**ATTACHMENTS FOR Planning and Environment Committee**

<b>Item</b>		<b>Page</b>
<b>3</b>	<b>498 BLAXLAND RD, DENISTONE. Application under Section 82A of the EP&amp;A Act, 1979, to review Council's determination of LDA2011/0257 for construction of affordable rental housing (under the Affordable Rental Housing SEPP) on the site. APL2012/0002.</b>	
	Attachment 4 Previous report - CIRCULATED UNDER SEPARATE COVER.....	2
<b>4</b>	<b>252 QUARRY ROAD RYDE. LOT 2 DP 701738. Local Development Application for Demolition and Erection of an Attached Dual Occupancy. LDA2010/439.</b>	
	Attachment 6 Previous report. CIRCULATED UNDER SEPARATE COVER.....	51
<b>5</b>	<b>64 PELLISIER ROAD, PUTNEY. LOT 102 DP 866280. Local Development Application for alterations and additions to the existing dwelling and new cabana. LDA2011/493.</b>	
	Attachment 4 Previous report - CIRCULATED UNDER SEPARATE COVER.....	97

- 2 498 BLAXLAND ROAD, DENISTONE. LOT 39 DP 7997. Local Development Application for Affordable rental housing (under the Affordable Housing State Environmental Planning Policy) comprising 5x2 storey dwellings on one property. LDA2011/0257.**

The objector has submitted the following illustration.

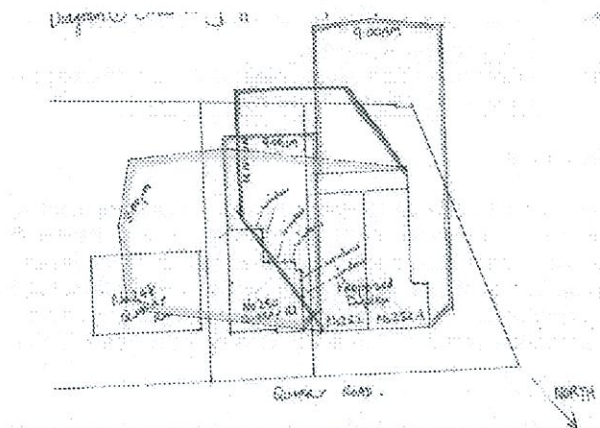
- o Unreasonable overshadowing as a result of poor design is unacceptable.
- o Sunlight to 50% of private open space is not reduced to less than 50% between 9 am – 3 pm on June 21.
- o Windows to north facing living areas of neighbouring dwellings receive at least three hours sunlight on June 21.
- o The residence will be affected by shadows from 10am to dusk on June 21 and will not be able to install solar hot water, their skylights will be in shadow and their clothes drying area will be affected requiring use of an electric dryer thus increasing their energy costs.

The objector also has had shadow plans (elongational and elevational) drawn up by a professional. The plans are attached to the objector's submission that is **CIRCULATED UNDER SEPARATE COVER**. The elongational plans are not dissimilar to the diagram above submitted by the objector. The objector's site faces north and the windows of concern are on the western side of the objector's property. The one closest to the street is a bedroom/home office window, the middle one is a laundry window while the third is a bedroom window, although it is designated sunroom on the shadow plans. The impact on the laundry window is not an issue of concern. An examination of the impact in the elevational plan indicates:

From 9 – 10am most of the shadow over the private open space is from the objector's property (including the existing dividing fence). At 3pm there is a significant impact with a large proportion due to the existing fence. There is a small area near the objector's garage that is not affected as well as the garage itself. There are a number of trees on the site but these have not been factored into the shadow calculations as trees can die, can be replaced or can be deciduous.

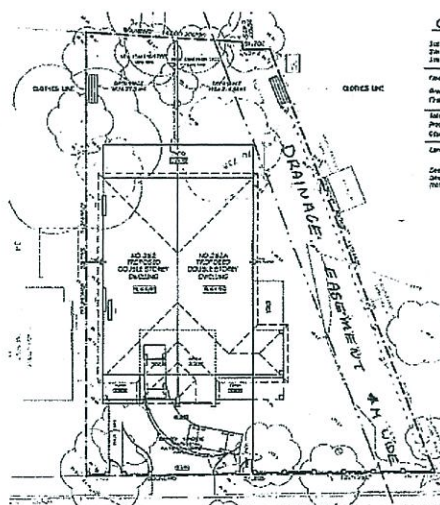
- *Overshadowing arising out of poor design is not acceptable, even if it satisfies numerical guidelines. The poor quality of a proposal's design may be demonstrated by a more sensitive design that achieves the same amenity without substantial additional cost, while reducing the impact on neighbours.*

**Comment:** The objector indicates the poor design causes the overshadowing impacts. There is disagreement with this view. The building is designed well and responds to the constraints of the site. The floor levels have had to be raised to facilitate overland flow, yet the floor to ceiling levels and the roof pitch have been reduced so that it complies with the height controls. It is within the floor space ratio requirements, its side and rear setbacks comply and its position on the site is governed by the 4m wide drainage easement and the need to maintain the overland flow requirements. The north south orientation of the site has a significant impact on the ability to provide sunlight to the proposal and to shadows caused by the proposal.

**Northern facing windows of 64A Pellisier Road**

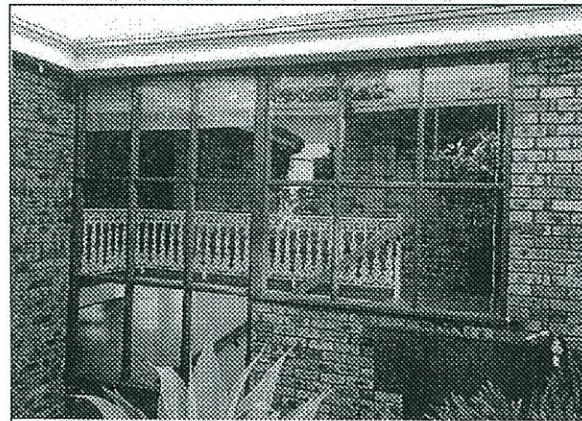
Overshadowing diagrams provided by the applicant indicate overshadowing of this part of the adjoining property will not be increased (see plans below). However, it is true to say that the extent of broader light penetration will be adversely affected by the development proposal as will amenity impacts from the additional floor level, especially from the rear proposed 'terrace' area and the cabana.

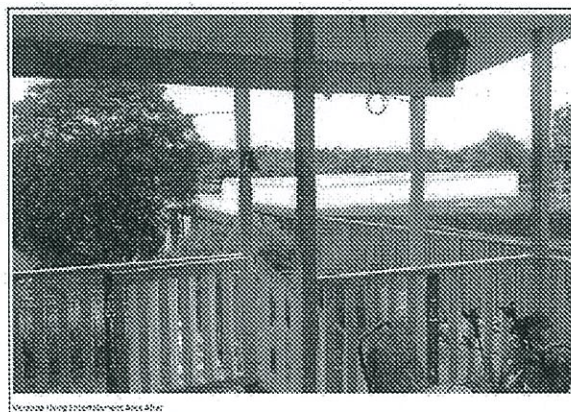
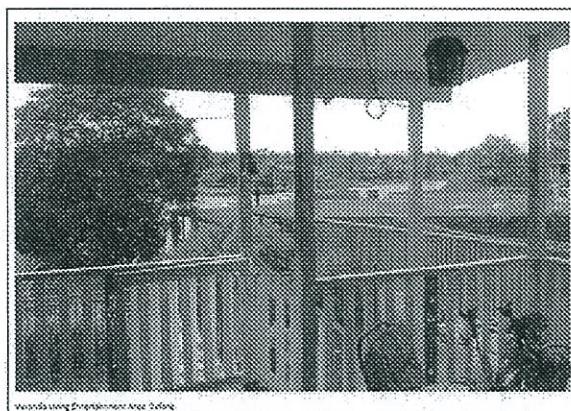
21. *The proposed upper level addition will completely block our direct views (whether seated or standing) from all living areas (kitchen, dining room and outdoor living area) and further block the current public view from Morrison Bay foreshore towards and of our heritage property. (Refer photos below)*

Having regard to the nature of the development, the circumstances of the case and the adverse impact that the proposal will have on adjoining and surrounding properties, it was not considered that the submission of a detailed heritage report by the applicant would serve any practical support of the development, particularly when considering the numerous non-compliances with existing state and local controls, and the overall adverse affect upon amenity and view loss of other adjoining properties (including the heritage item).
